Addendum No. 1
March 18, 2026

Project: Union County Courthouse Addition and Renovation
Elk Point, South Dakota
Architecture Incorporated Project Number 0728.2893.20

Scope of this Addendum:

BASEMENT - DEMOLITION

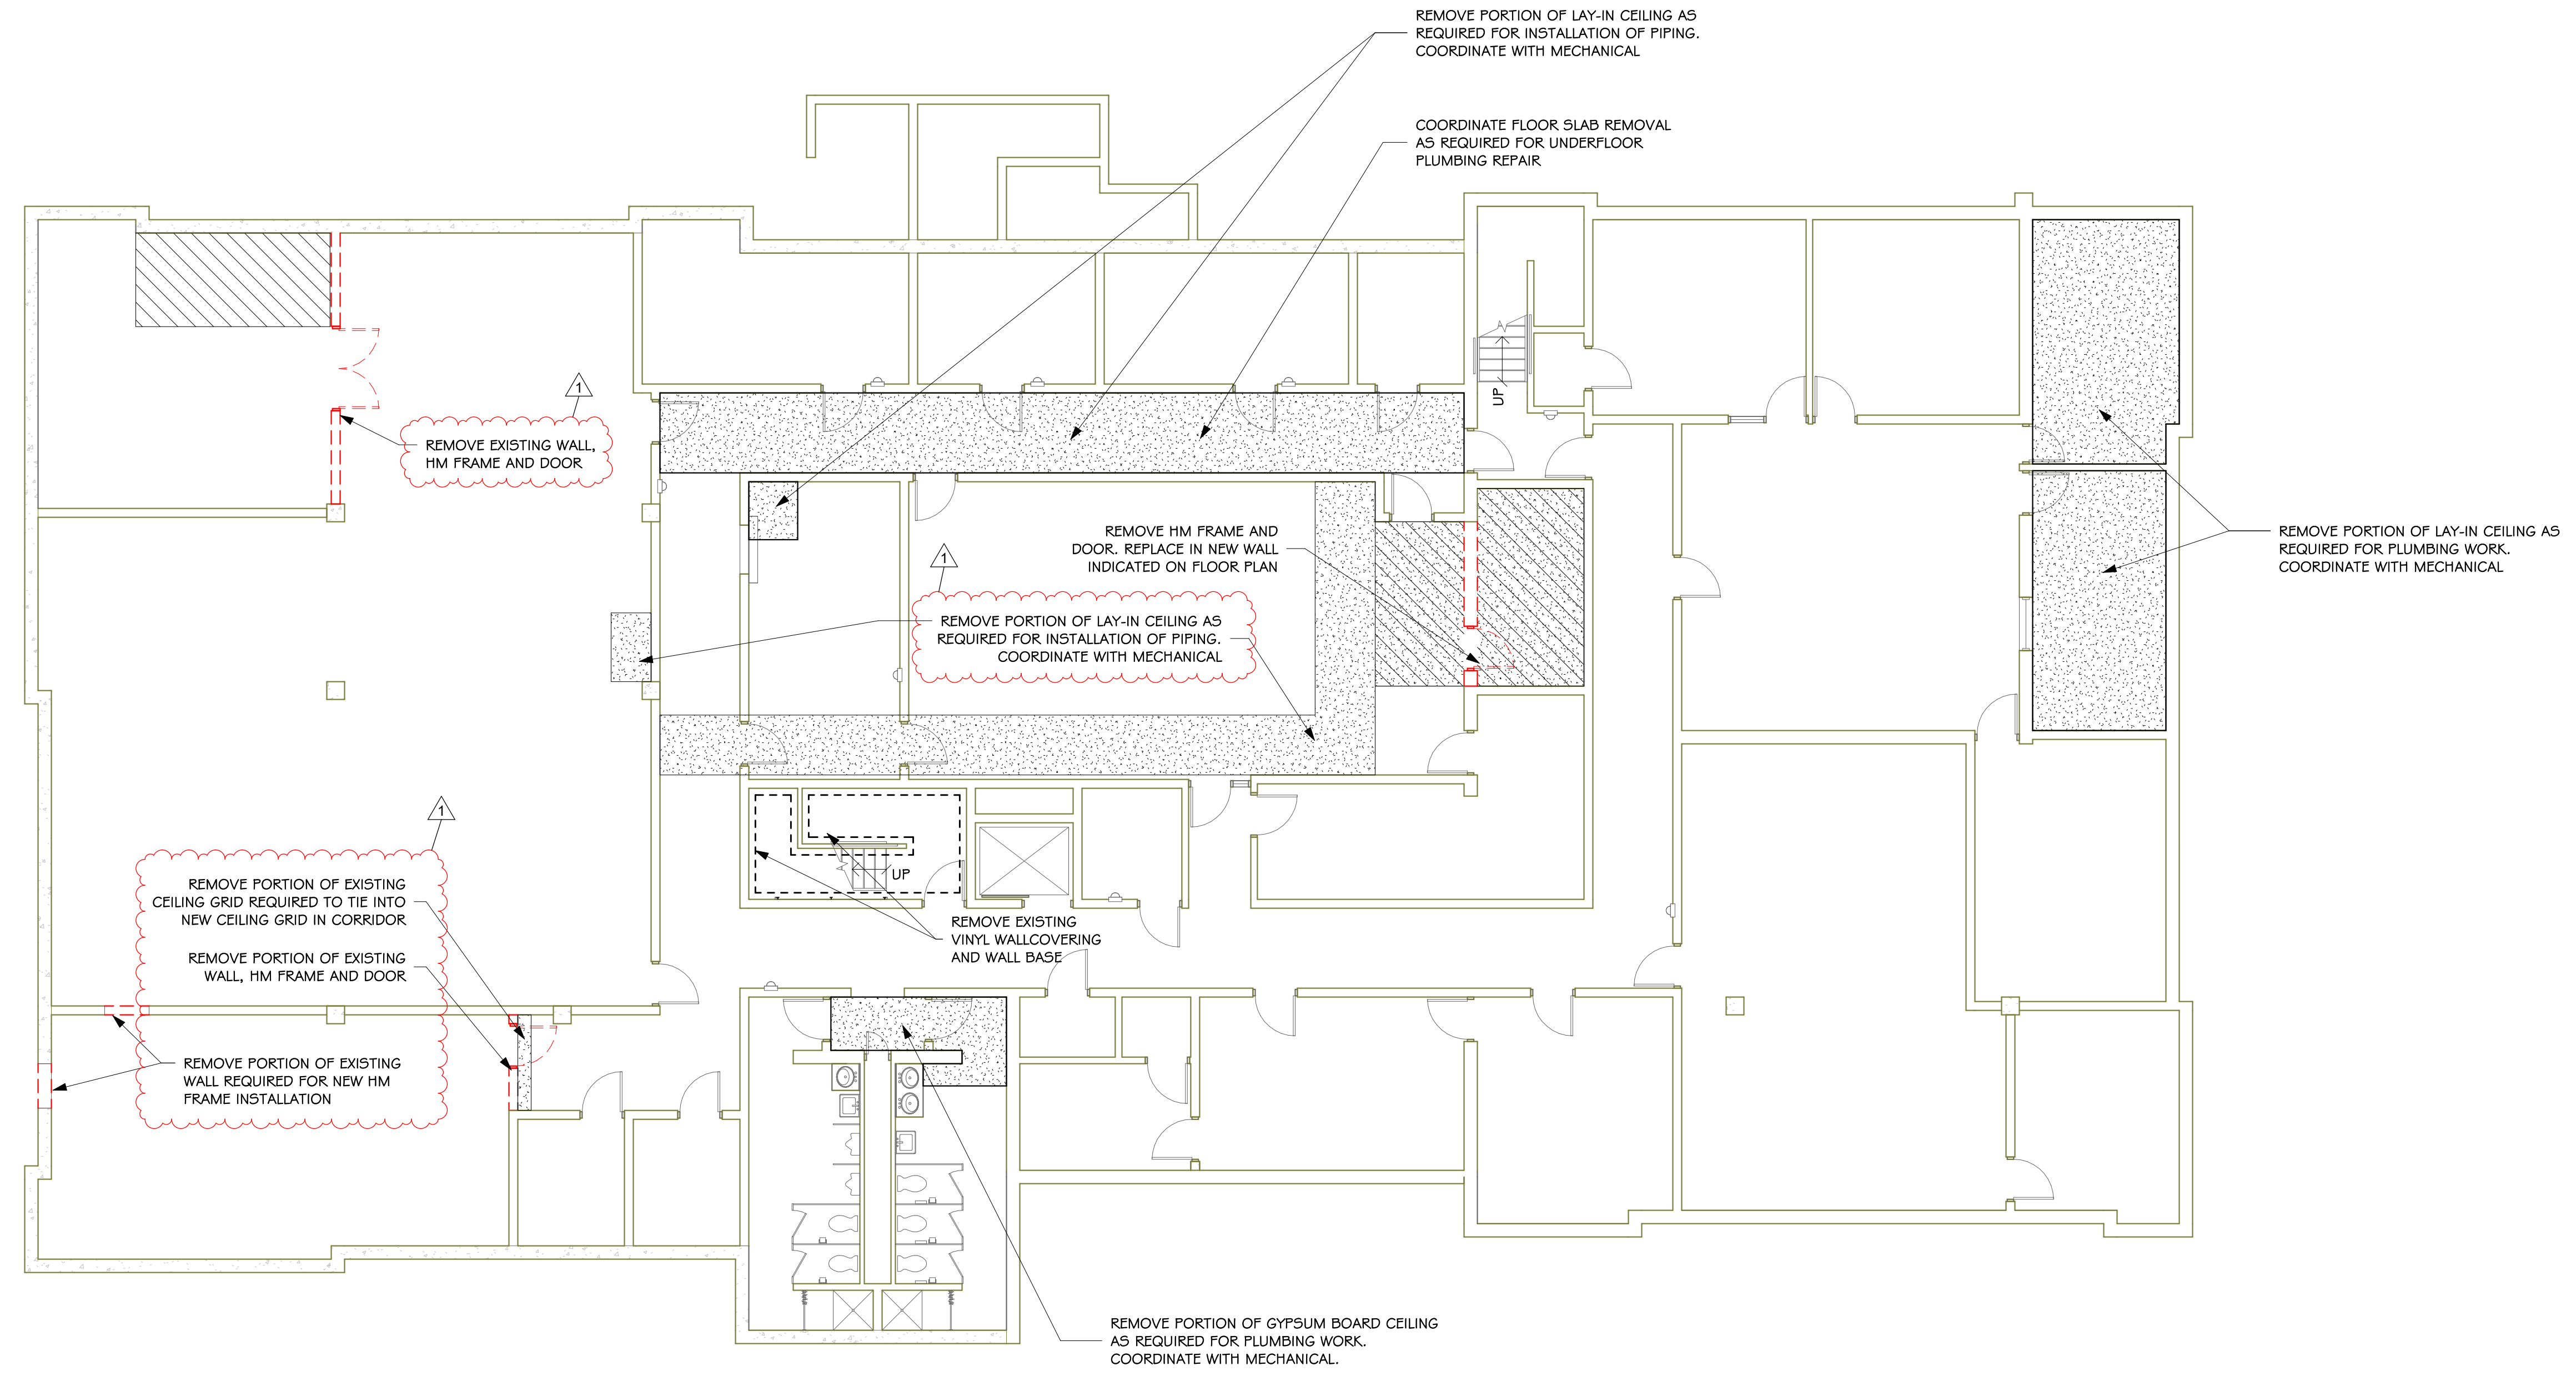
- 1) PRE-BID MEETING MINUTES
 - a. Reference the attached Meeting Minutes from the Pre-Bid Meeting on March 17, 2026.
- 2) CLARIFICATION
 - a. Attached drawing sheets from the original Courthouse project are included FOR REFERENCE ONLY.
- 3) SECTION 011000 – SUMMARY
 - a. Article 1.4.A.2: Modify as follows – Commencement of Work: Work can start on or about April 13, 2026
 - b. Article 1.4.B: - Modify as follows – Substantial Completion: October 29, 2027
 - c. Article 1.9.H: Omit requirement for Employee Screening.
- 4) DRAWING SHEET 4.00 – DEMOLITION BASEMENT PLAN
 - a. Omit the following notes as shown on the attached updated Drawing Sheet 4.00.
 - i. 'Coordinate Penetration for new communications cabling'
 - ii. 'Coordinate floor slab removal as required for underfloor plumbing repair'
 - b. Add demolition notes as shown on the attached updated Drawing Sheet 4.00.

FIRST FLOOR PLAN - POWER & SIGNAL
SCALE: 1" = 12'

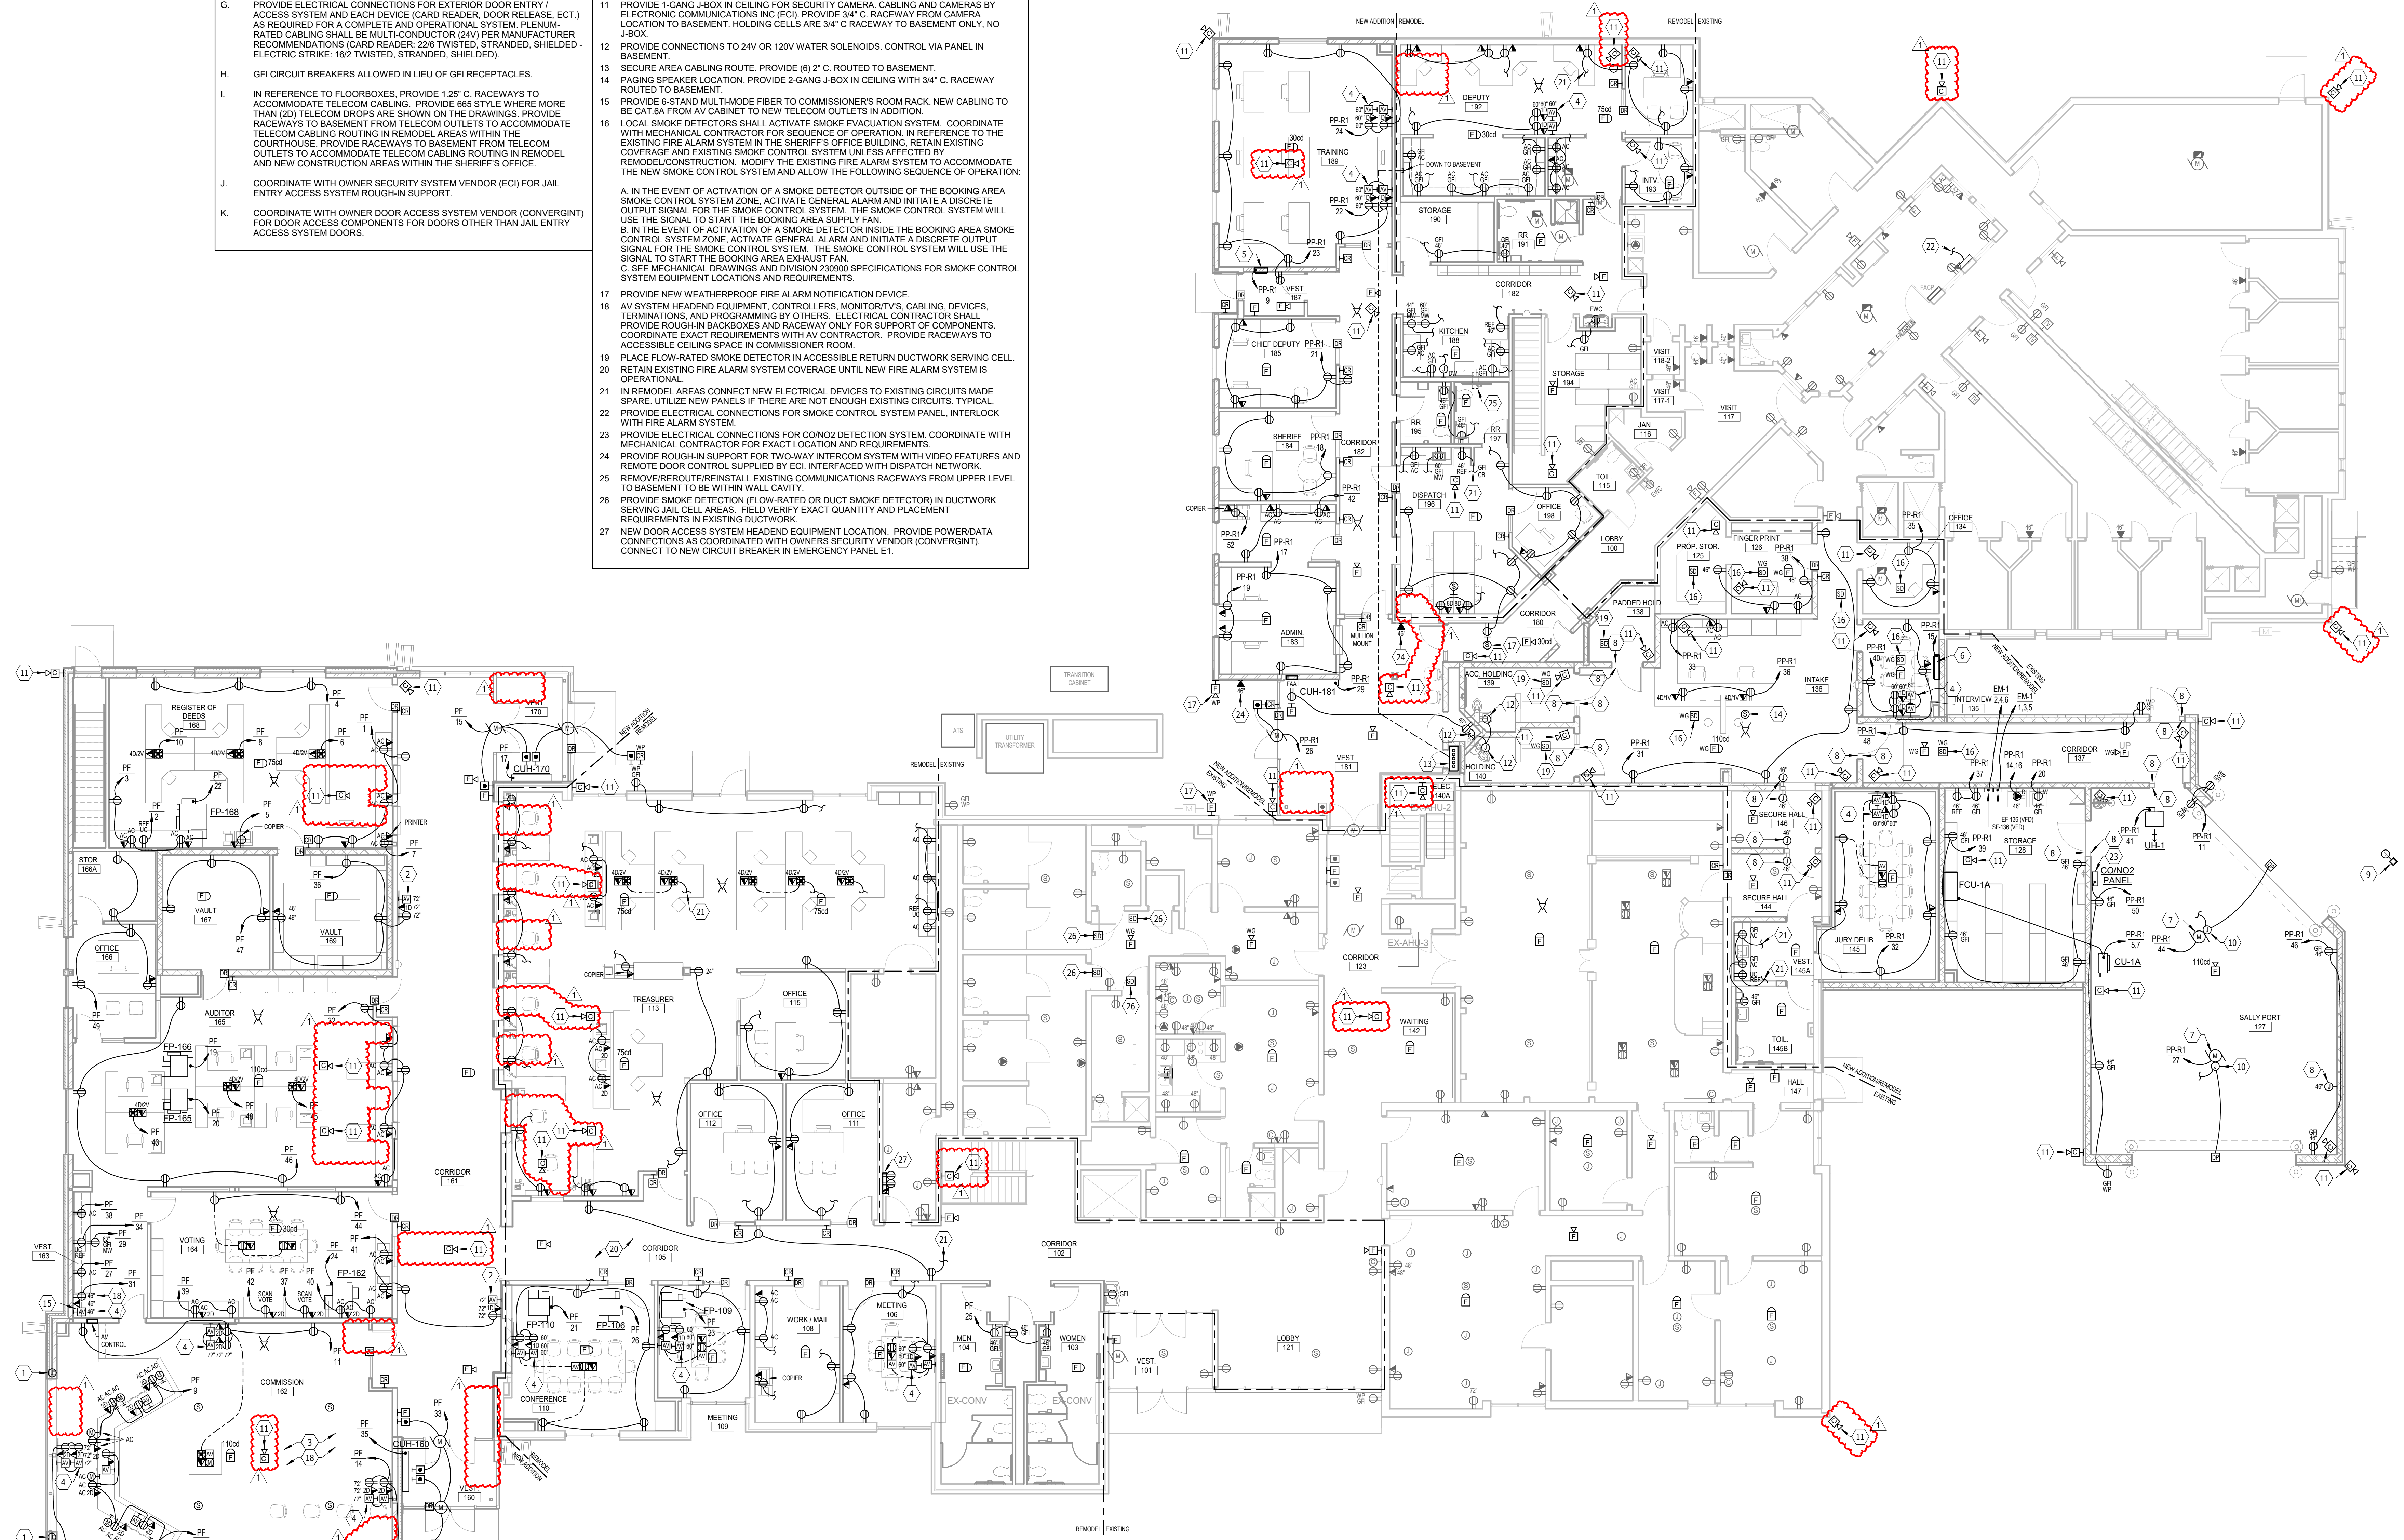
1) DRAWING SHEET 9.33 - FIRST FLOOR PLAN – POWER & SIGNAL

- a. See attached revision drawing for updated security camera locations.
